NYBERG RIVERS

Response to City of Tualatin Letter

Addendum #1 to the Master Plan submitted March 19, 2013

RE: Review Comments: Nyberg Rivers Master Plan (MP-13-01)

TRANSPORTATION PLAN

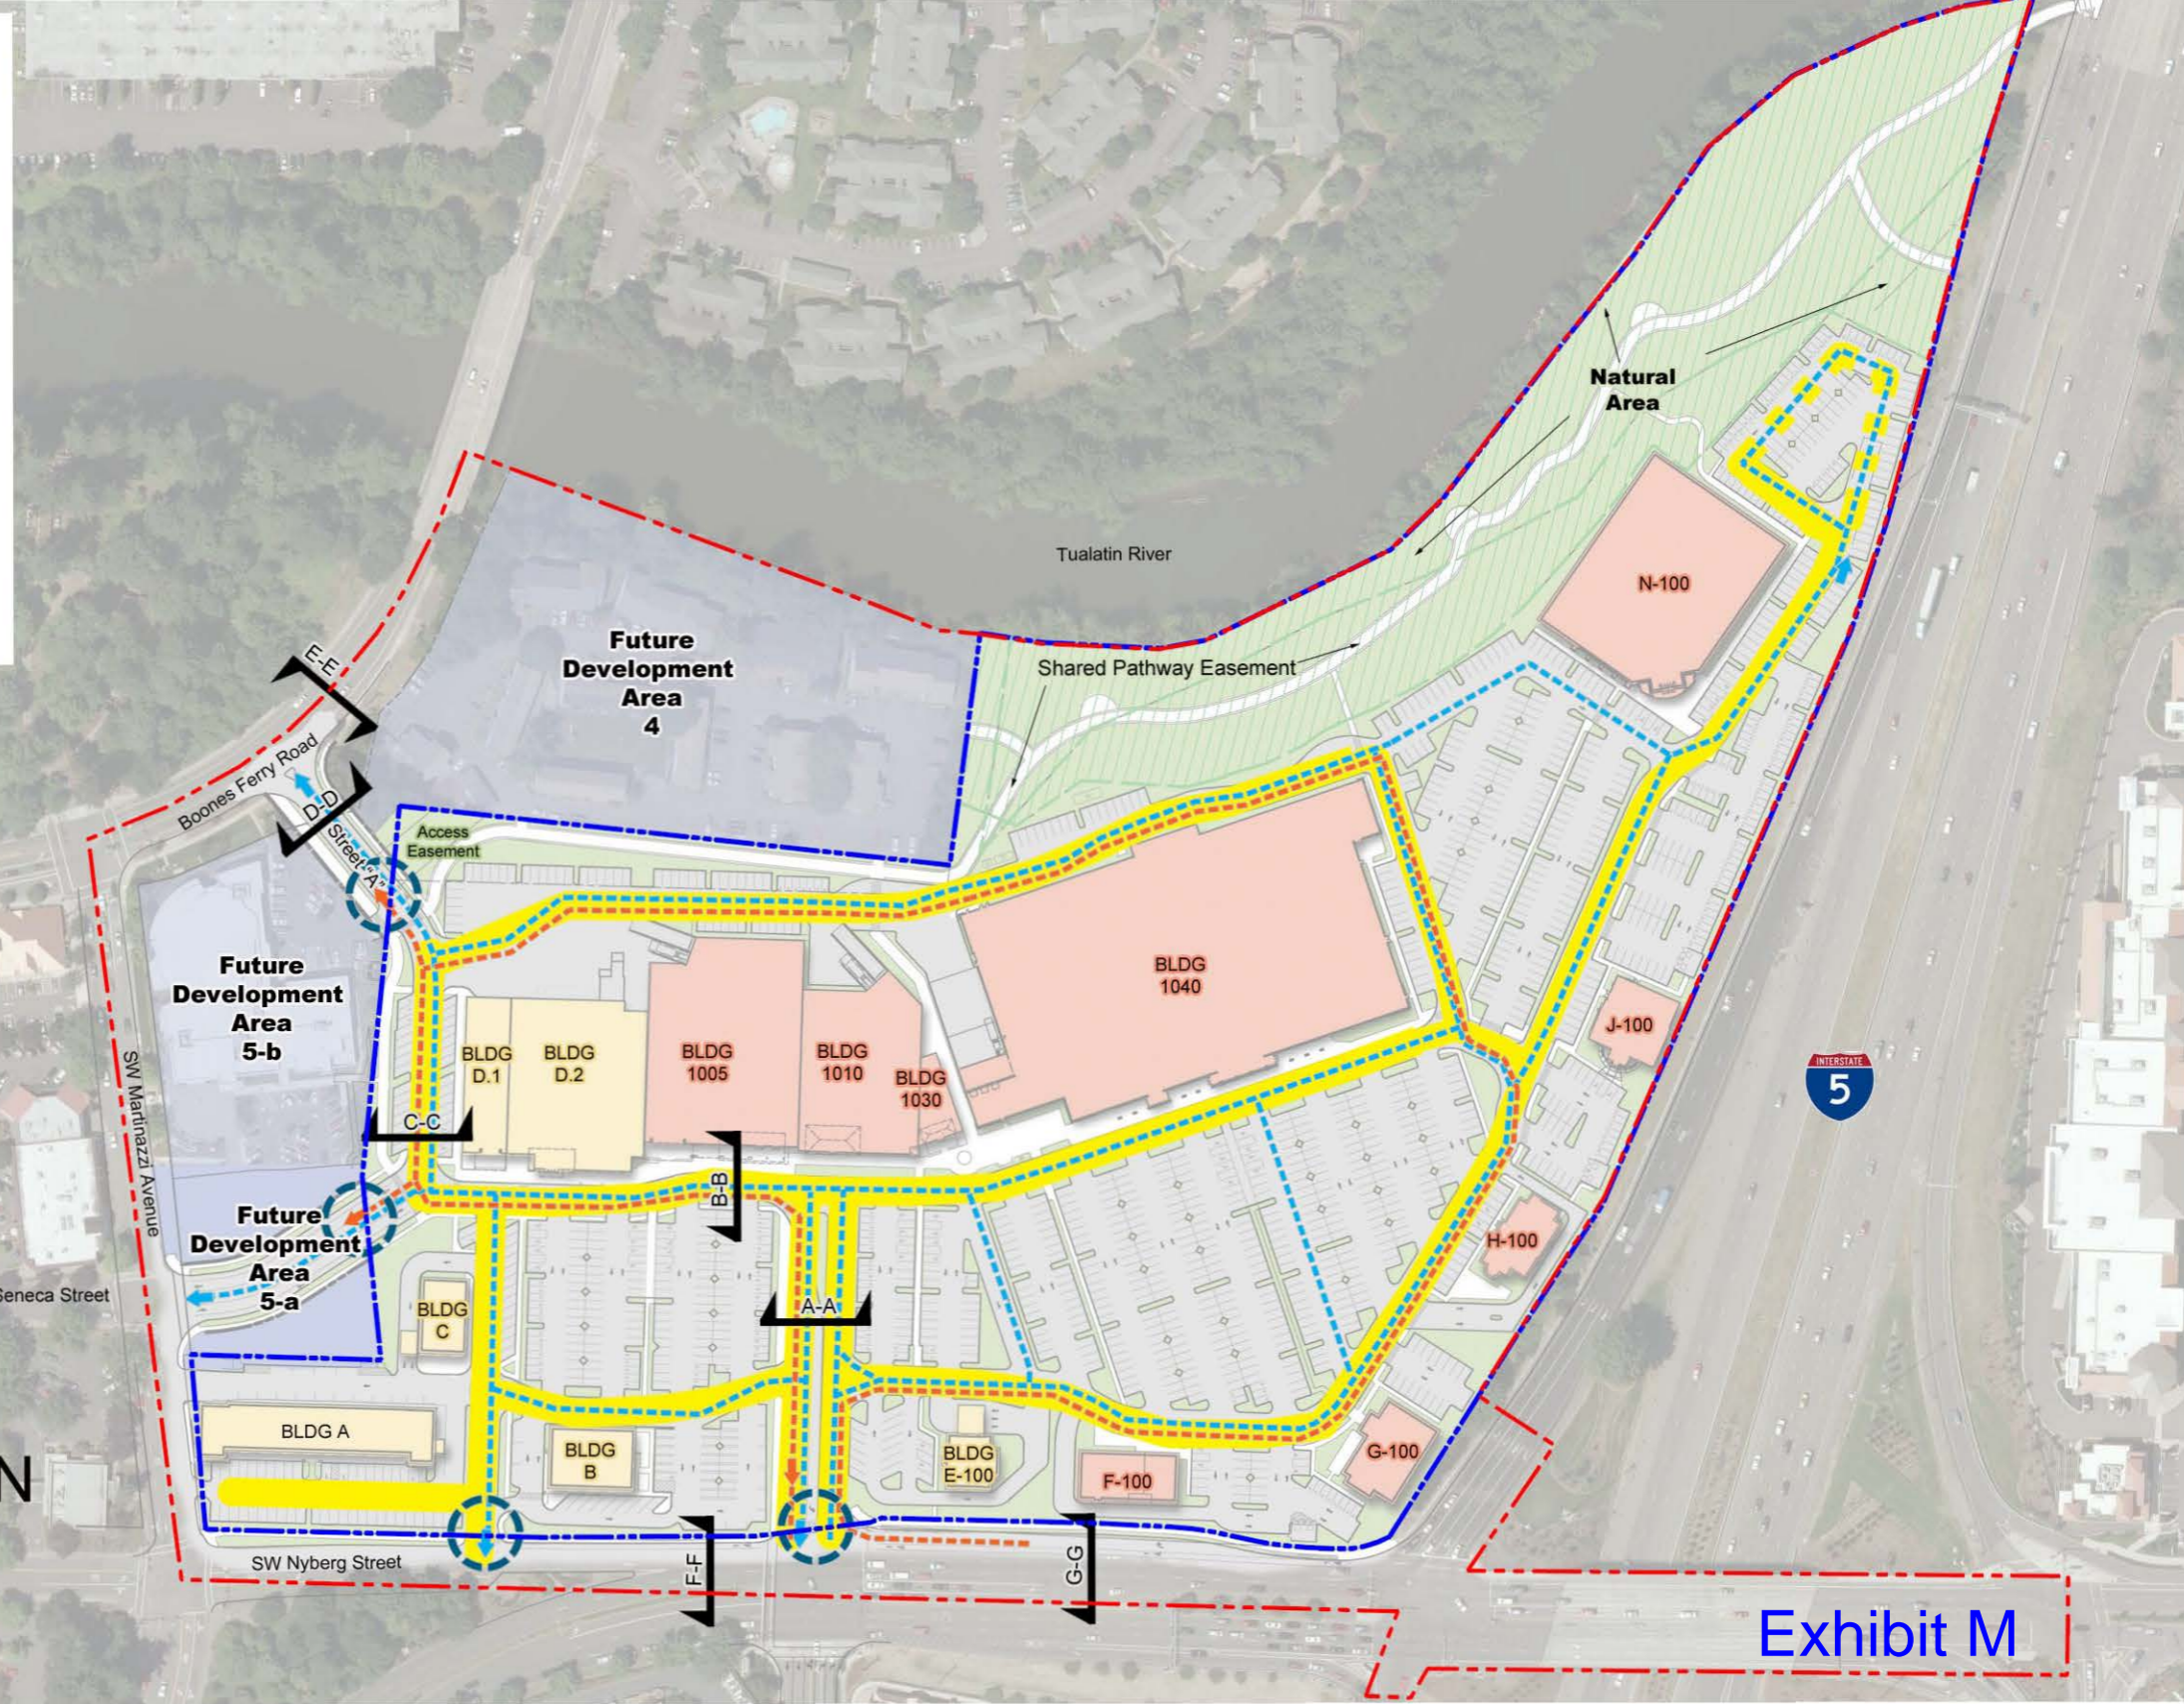
Truck Circulation - As proposed, truck access will have substantial traffic, noise and safety impacts for adjoining residential and City Campus developments. Please provide a plan for truck access that does not rely on SW Martinazzi Avenue and SW Boones Ferry Road access features. A lot of pedestrians use this area to access the library and City services. It is inappropriate as a freight route. Please resubmit with a new proposed freight route on Master Plan Summary Page 8 and any other sheets that need the corrected reference.

Fire Access Aisles Width - Fire Department accesses need to be clearly located and identified. Onsite drive aisles that are a part of the Fire Department Access must be a minimum of 26 feet in width and provide proper radius for maneuvering emergency vehicles. Currently, the plan indicates a 24 feet width in most locations. Please adjust the Master Plan site plan(s) accordingly and identify the fire access routes (see attached comments from TVFR).

The Cardno Response provides a new truck circulation route as requested by the City. That route is shown on the Transportation Plan, Exhibit M, provided with this letter. The truck access area provides 26-foot drive aisles and has been re-designed to minimize privacy, safety and noise concerns consistent with this request.

Fire Department access is clearly shown on the updated Transportation Plan under Exhibit M and is provided at a minimum width of 26-feet. We understand from later discussions with the City that there may be some flexibility to reduce the width to 24 feet in order to add 2 feet to the plaza. We could accommodate this request but need to be assured that such a width is also acceptable to the Fire Bureau.

The Cardno Response shows 3 fire access points at 3 locations. With one access at the Nyberg Street traffic signal, secondary access is provided at the Street "A"/Boones Ferry Road entrance and the SW Seneca Street/SW Martinazzi Avenue signal. The Site Plan has been

designed to accommodate fire access through the site, with 26-foot drive aisles and truck circulation to provide safe access through the site. This circulation is shown on the attached Transportation Plan, provided under Exhibit M. The applicant will continue to engage with the fire department to ensure the fire access point requirements are met including providing sprinkled protection systems and utilizing appropriate building materials.

EXHIBIT Q 1-BUILDING FRONTAGE LANDSCAPE PLAN

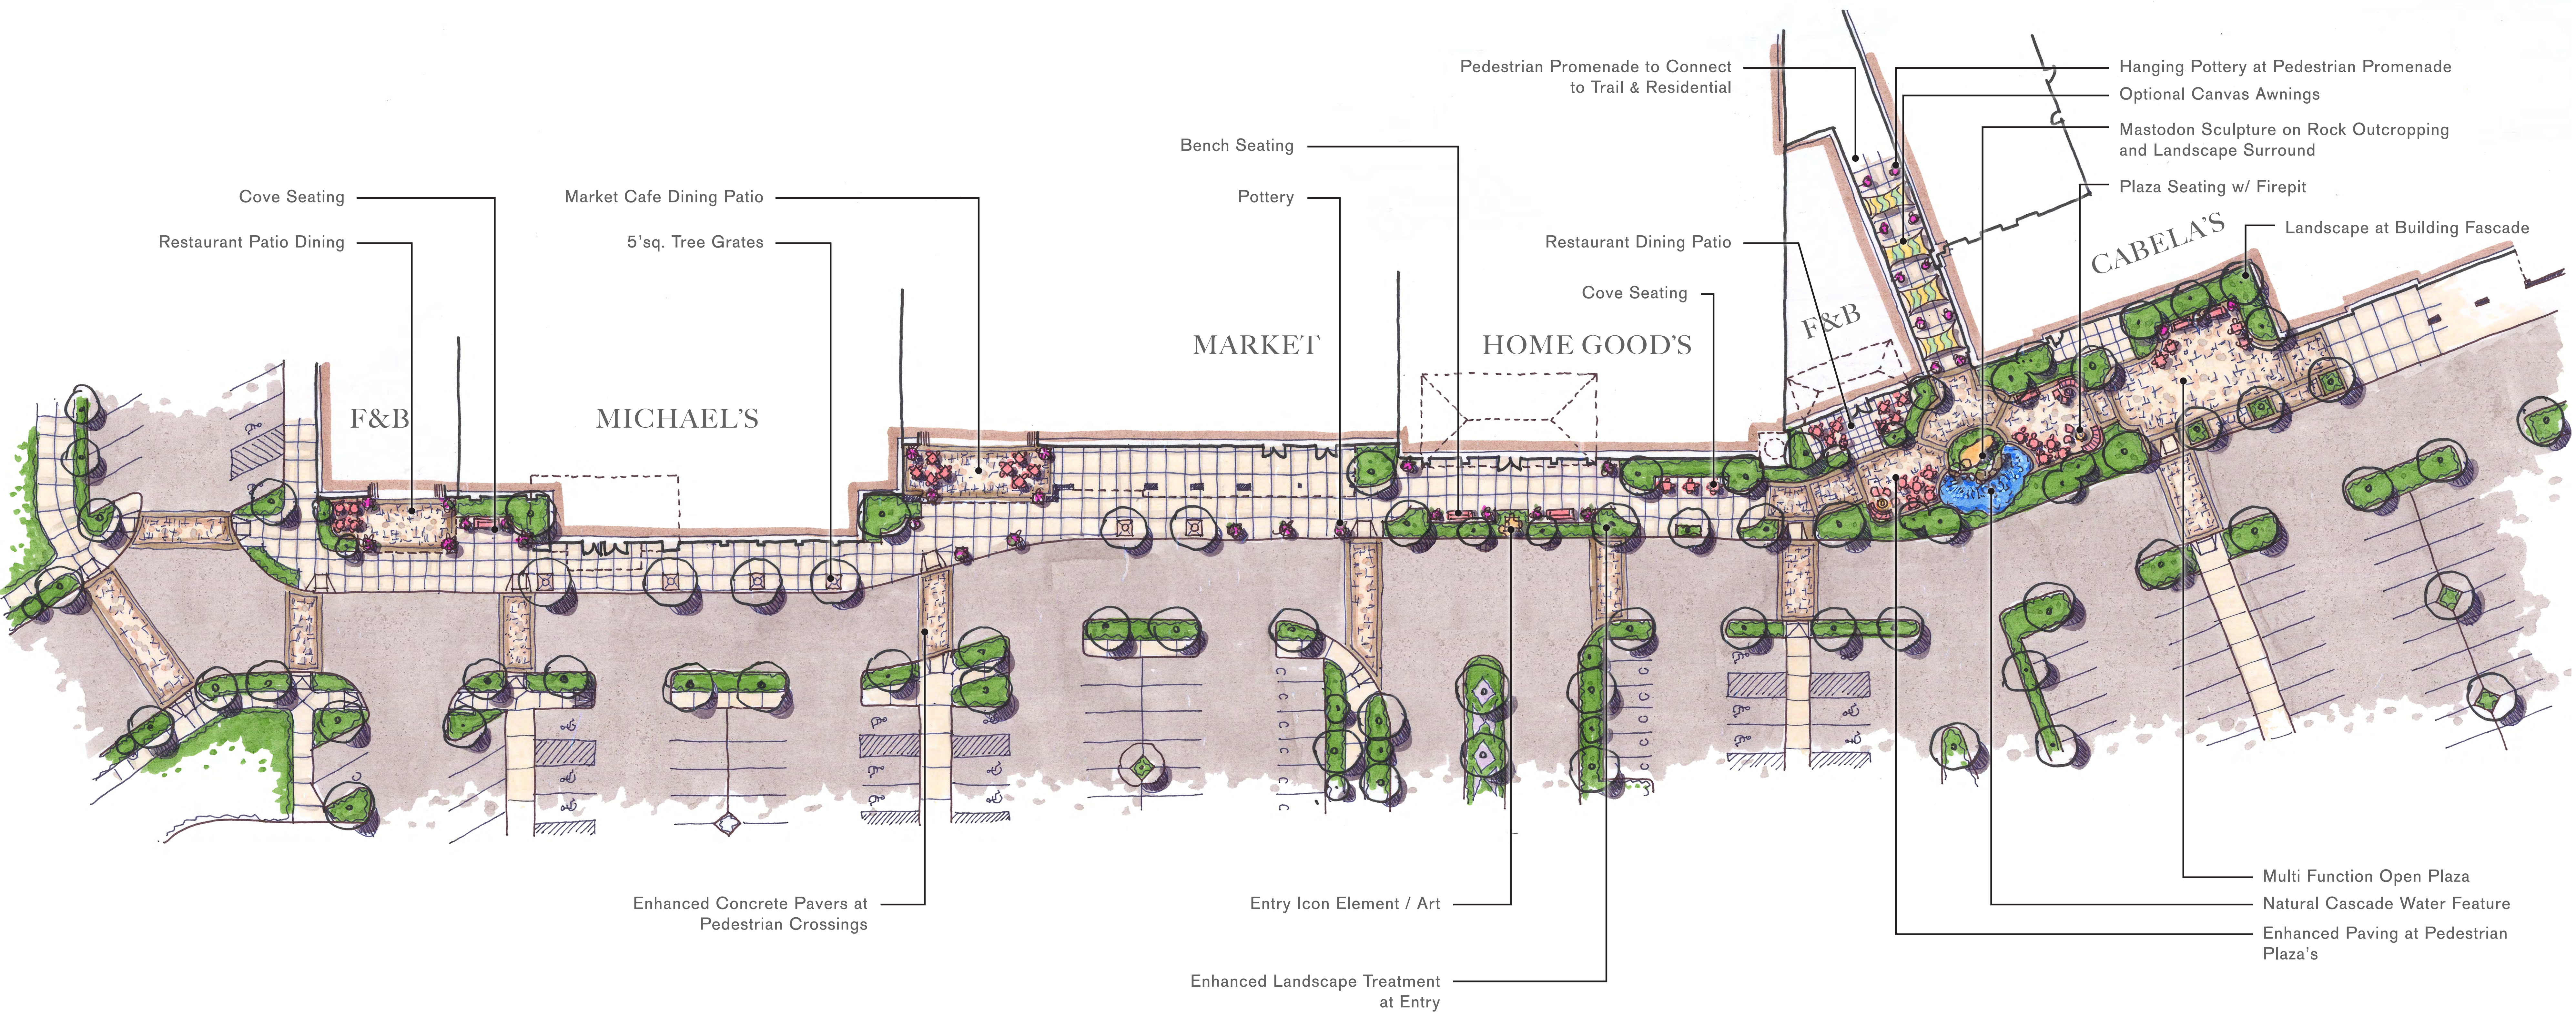
Include detailed plans that show the scale and features of plazas that identify any potential conflicts with bicycles and pedestrians, and that show public benefit. The function of plazas and public spaces also serves a portion of the overall goal of the Central Urban Renewal Plan to strengthen social and economic development and encourage outdoor uses. The currently proposed public spaces and plazas should be revised to make the spaces larger in order to contribute to community gathering spaces. In the main shopping center area, no portion of any sidewalk extending from the western storefront to the eastern storefront should be less than 12 feet in width. The current plans show smaller dimensions in some places.

A revised Exhibit Q reflects the proposed changes CenterCal has incorporated into the Plaza design as a result of the City's June 3rd letter to CenterCal.

The applicant has proposed a plaza on site as well as a network of streets and sidewalks that provide community gathering spaces and pedestrian amenities. As shown on Exhibit Q 1 and Q2 attached with this letter, there are several amenities provided to create an enhanced pedestrian experience throughout Nyberg Rivers. Amenities include cove and bench seating, patios, tree grates, sculptures, water features, a pedestrian promenade, and larger sidewalks to promote pedestrian interaction and safe access through the central shopping corridor, as well as linkage to the north/south pathways into and through the parking areas and remainder of the site.

EXHIBIT Q 2-BUILDING FRONTAGE LANDSCAPE PLAN

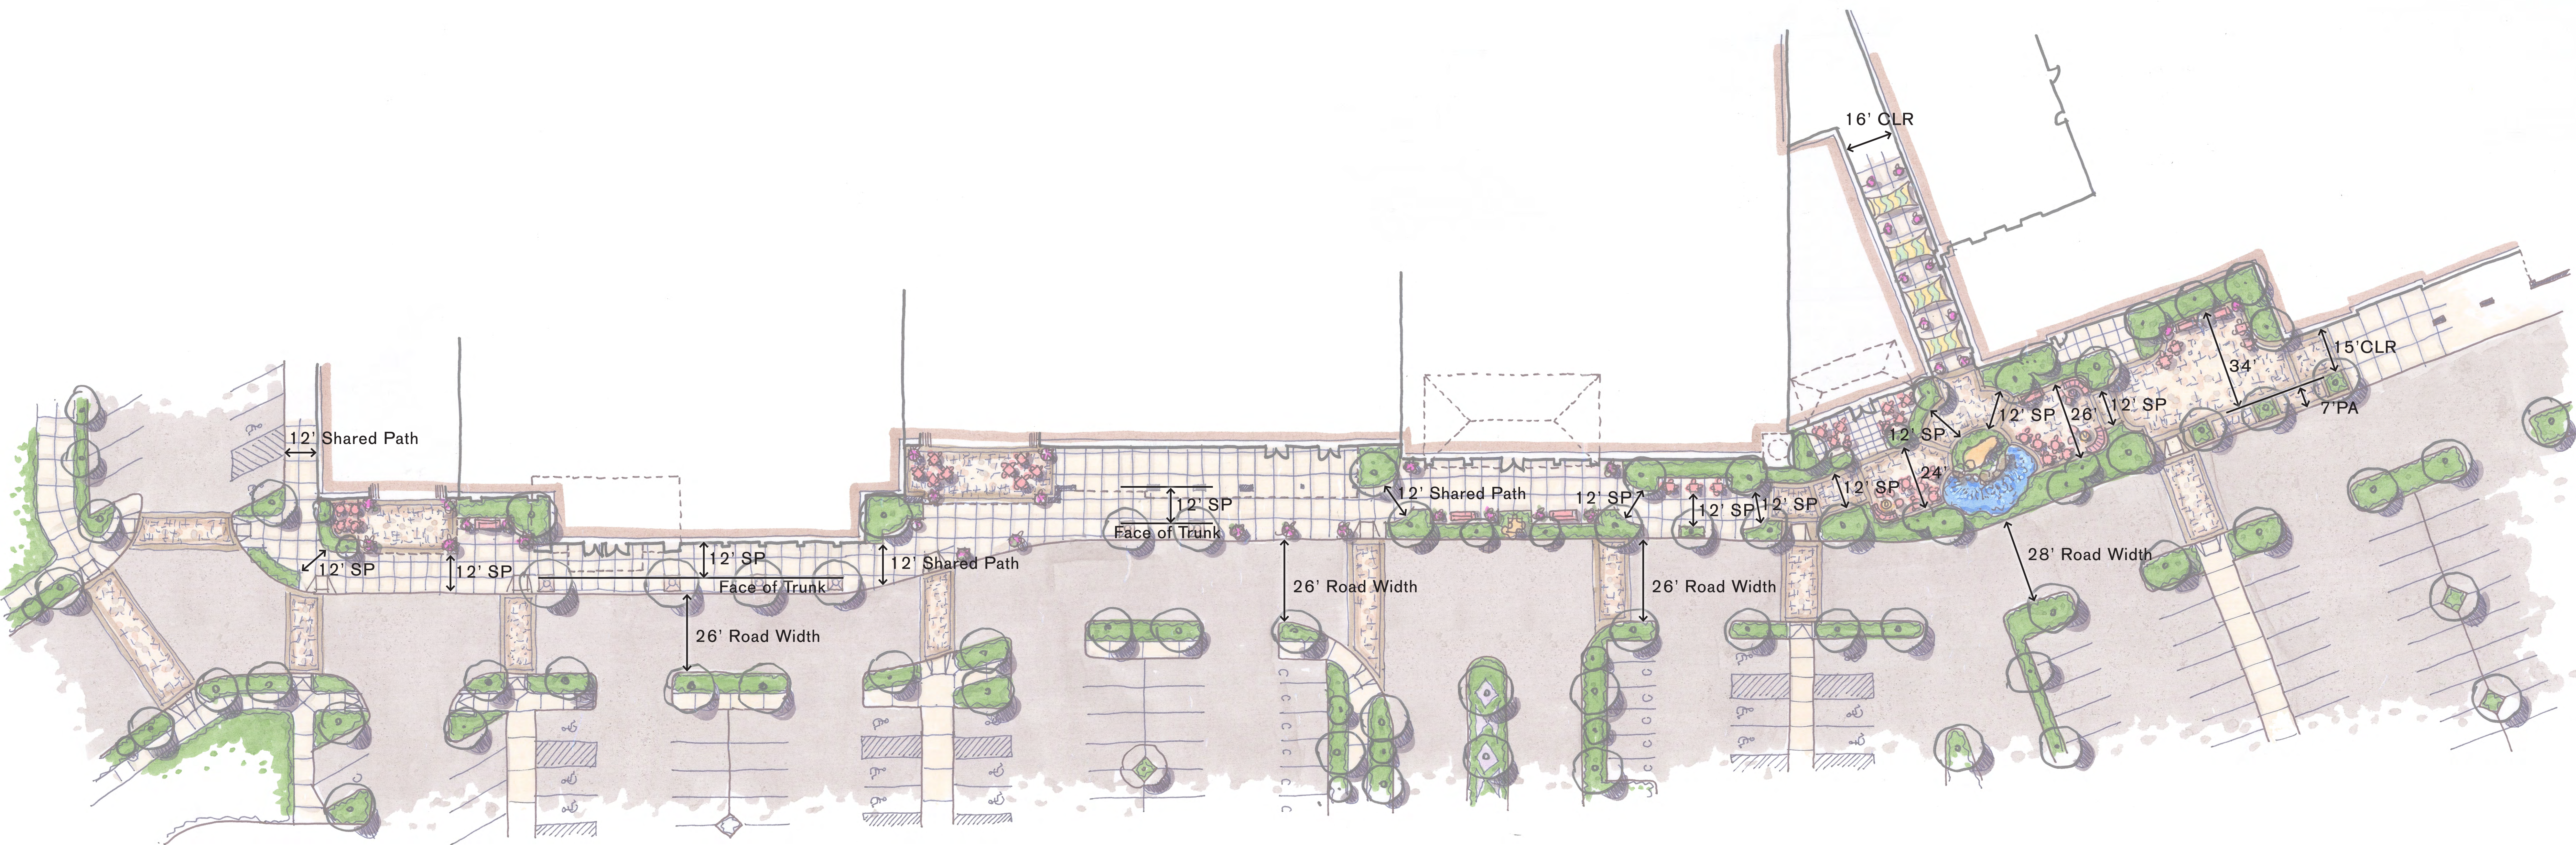
The CURD Plan identifies the Nyberg Rivers site as part of the Tualatin Downtown. The proposed Master Plan does not clearly show or explain the project's elements and connections to downtown. Please refine the Master Plan to address how the proposal addresses this issue.
